Aga Khan Planning and Building Services, Pakistan  
Building and Construction Improvement Programme – BACIP

# **FIELD VISIT HABITAT RISK MANAGEMENT PROGRAMME (HRMP)**

**NOVEMBER 2008**

**Left:** Outside wall of the main room with foundation ring beam and wall stitches.

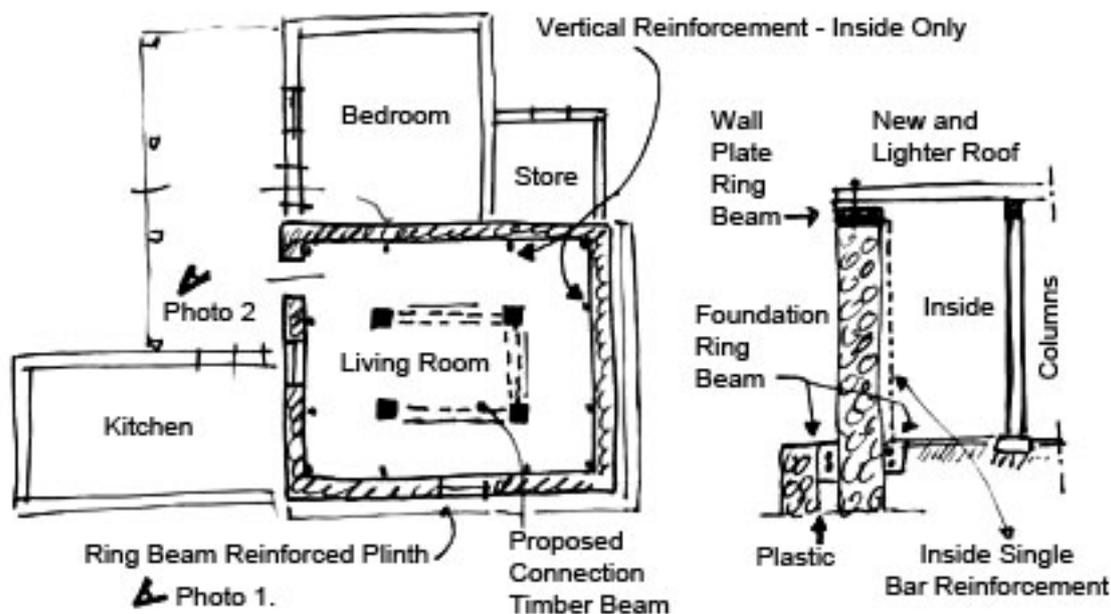
**Right:** House owner in front of bedroom – the lintels are not linked nor connected to the main room wall plate ring beam (right of bedroom door).

The stitching looks impressive, but it is more a psychological improvement as it contributes little to the overall strength of the room. In the event of an earthquake, it will be the upper wall plate ring

Neither the lintels over the door and window of the bedroom (see photo page 2, right), nor the lintels of the kitchen, were connected to the ring beam of the main room. This was based on the idea that the programme would only improve the main living/guest room. The mission was of the opinion that it would have made more sense to avoid disturbing the massive old columns and instead connect the interrupted lintels to the ring beam (for less cost). Only the living room (or the visitor's part of the house) was dealt with, while the occupants obviously would spend most of their time in the bedroom (12 hrs/day), the kitchen (6 hrs/day) and outside.

- Retrofitting traditional houses having strong wooden support columns should consist of lightening, insulating and waterproofing the roof construction; and reconstructing the walls using less material, but with internal wall reinforcement and cement mortar, and applying thermal insulation.
- Retrofitting should include the **entire house** and not only one room. In addition, a seismically retrofitted room should be adequately strong enough to allow the possibility for a future lightweight upper storey. The design of lightweight constructions would be a challenge for BACIP.
- Local stitching of cracked walls consisting of masoned stone and rubble does not add much to the strength of the wall as a whole, making it a costly exercise that should not be repeated. It is better to frame the entire wall sections as shear walls.

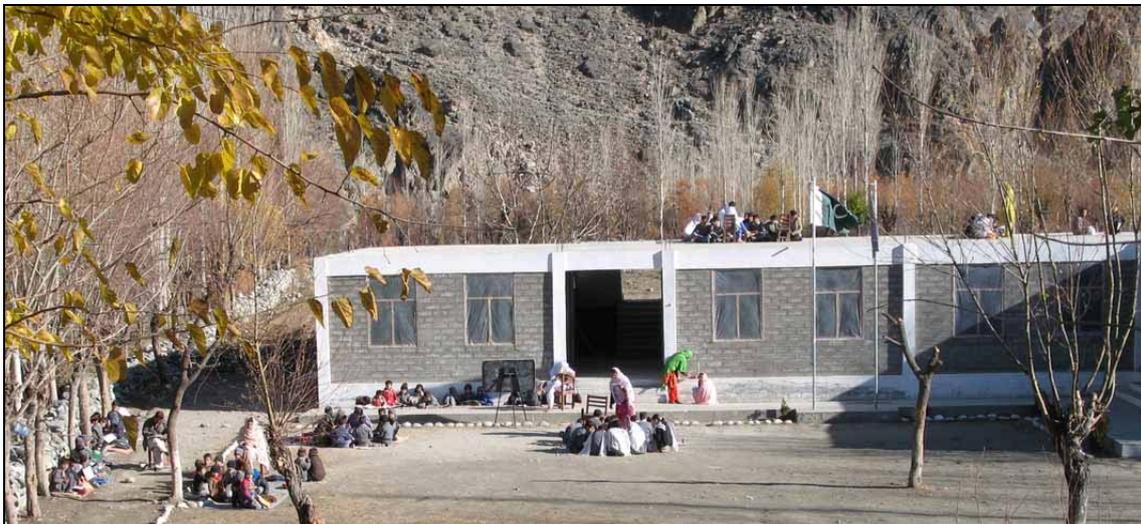
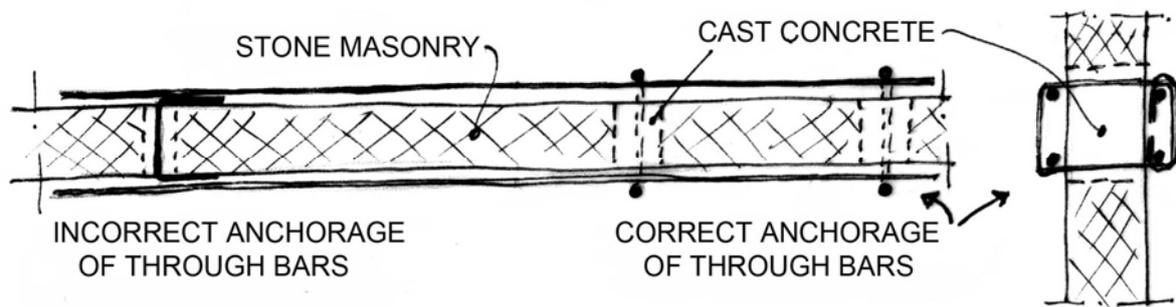
In retrofitting the school, internal wall reinforcement bands and columns have been connected through the existing wall to external bands and columns at multiple locations. This creates wide structural beams around the perimeter walls and corners; giving great lateral strength and function as tie beams. Although care was taken with the making of the stirrups of these lintel beams, the connections between inside and outside beams were **insufficient in number and without double bar links**. In many cases, only single bars were used for through connections.

As could be observed from the reinforcement details of one of the exterior columns, the lintel strip reinforcement is going inside the vertical reinforcement while these should be fitted around the vertical reinforcements.

In addition, in the opinion of the mission, the number of through-the-wall anchoring is insufficient and the single bar with hook inadequate.

The connection between the inside ring beam and outside ring beam is based on only one single bar passing through the wall instead of going back again, making a full loop. The number of through connections between the inner and outer ring beam is rather low. The vertical bars are from the window framing, placed correctly<sup>3</sup>.

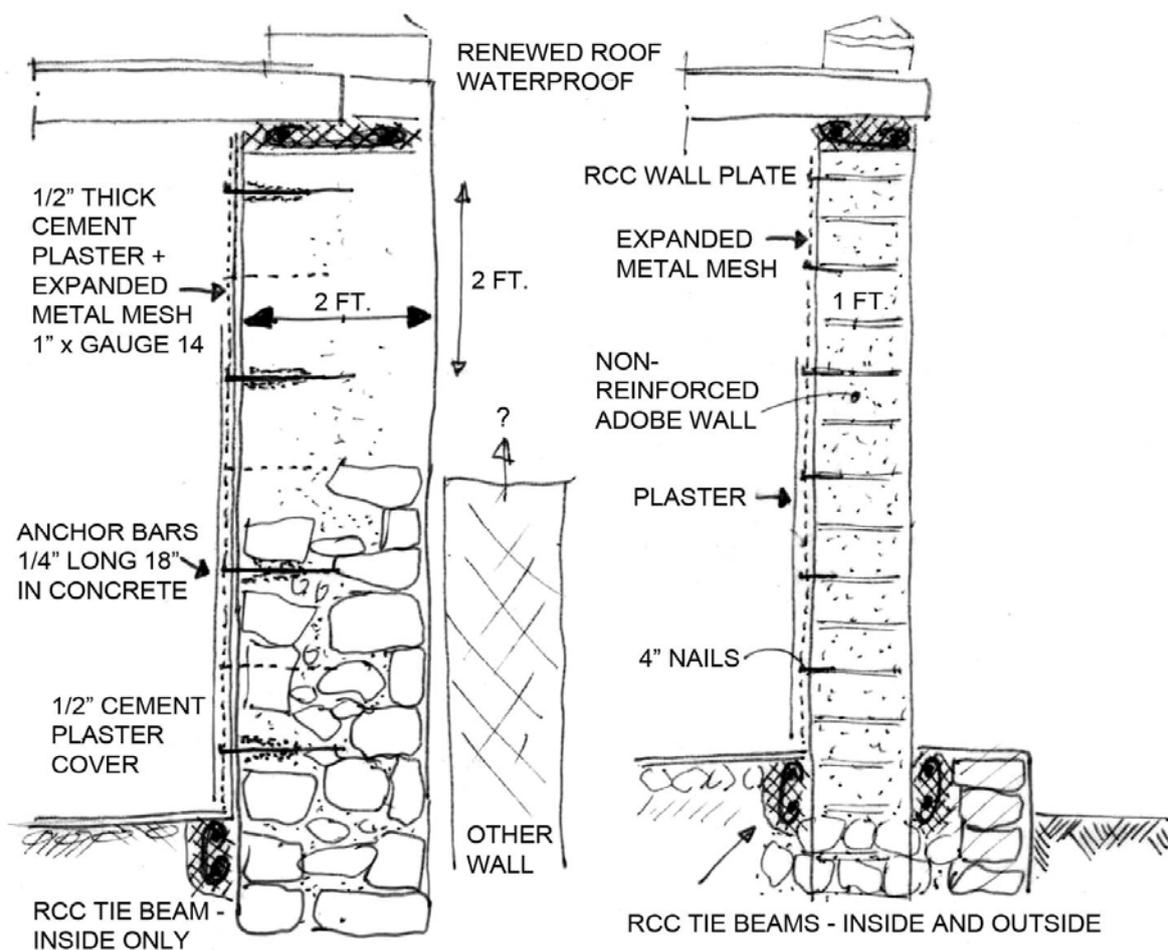
- Such a construction is not only costly, but strengthening only one face of a weak stone wall does not really add to the strength of the wall to withstand earthquakes, especially not when it is a supporting wall. In the case of a 2-ft. thick rubble stone masonry wall, the **best thing is to totally reconstruct the 20-ton wall** and reconstruct it in a lighter way. The two sketches of House 4 and House 5 (below) are the technical details according to the architect.

**Left:** This sketch illustrates the technique used to anchor the 2-ft. heavy stone and rubble wall of House 4 where a 1" expanded metal mesh and plaster is placed on one side only. The cemented anchors will only grab onto some of the outer face stones. Because the rubble stone masonry walls are internally loose, it does nothing for the other face.

**Right:** Sketch of House 5. The anchoring in the adobe wall is even worse. Those anchors hold onto nearly nothing in the adobe or clay bricks.

The proposal for strengthening the inside wall of the house was even more surprising than House 4 because the expanded metal mesh was supposed to be “nailed” into the adobe (see sketch page 9, right). To the opinion of the mission, the money would have been better spent on a thermal wall construction because the current “wall reinforcement” will fold like a sheet of cardboard when the adobe wall fails during an earthquake.

Adobe walls should be entirely reconstructed with the GWR instead of applying external “reinforcement”.

View of the massive foundation ring beam of the small one-floor-only adobe house

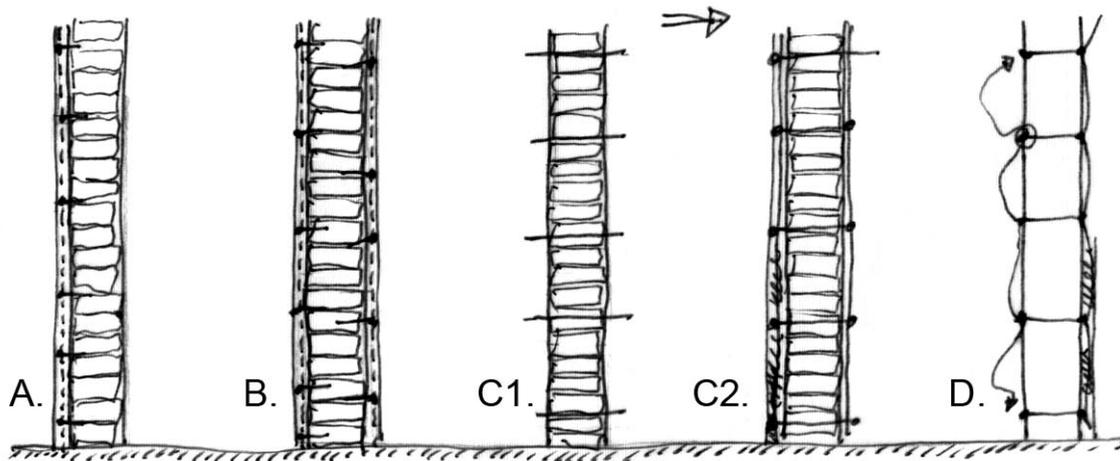
Here a massive foundation reinforcement inside and outside was realised and the roof lightened. A single bar between the foundation and roof will be applied in the four inside corners of the main room and plastered. These bars won't hold up anything if the wall fails. The detailing of this corner solution is surprising because in the school design there were through connections in the corners, creating double and anchored columns; why then not in a weaker adobe house?

Considering the massive inside and outside foundation ring beam reinforcement; the unnecessary non-seismic wall with expanded metal mesh; the unnecessary and non-functional inside corner bar reinforcement; and the obligation to make a wooden wall plate tie beam instead of using the low-cost GWR reinforcement, makes this adobe house an example of how retrofitting should **not** be undertaken.

- Based on the excessive work and cost of the foundation ring beam for a ground-floor-only adobe house, as well as the nonsense internal wall reinforcement, **the mission advises to review the technicalities of this kind of retrofitting.**

The top sketch shows the position of the vertical reinforcement in Houses 1, 4 and 5.

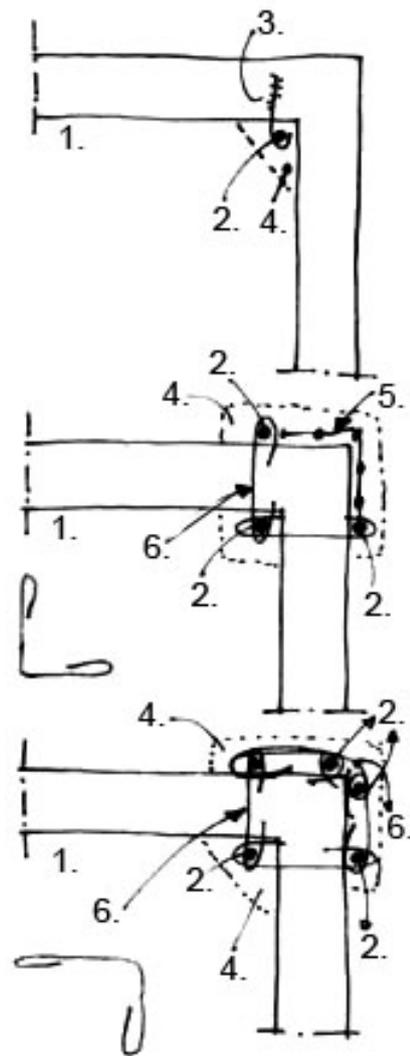
The single bar (2) is supposedly anchored between the foundation ring beam and wall plate ring beam, and possibly nailed (3) to the wall (1).

The inside corner bar is then plastered (4).

This solution does not provide sufficient anchorage of the bar, with the effect that the bar will pop loose from the wall during an earthquake.

The second sketch shows a suitable minimum design.

The inside bar (2) is linked to the outside bars (2) in two directions (6). L-shaped bars can be used.

The two vertical outside bars are linked around the corner with a strong wire mesh (5), and the reinforcements are covered with strong cement mortar plaster (4).

For vertical wall reinforcement, columns need to be formed by linking the inside and outside bars.
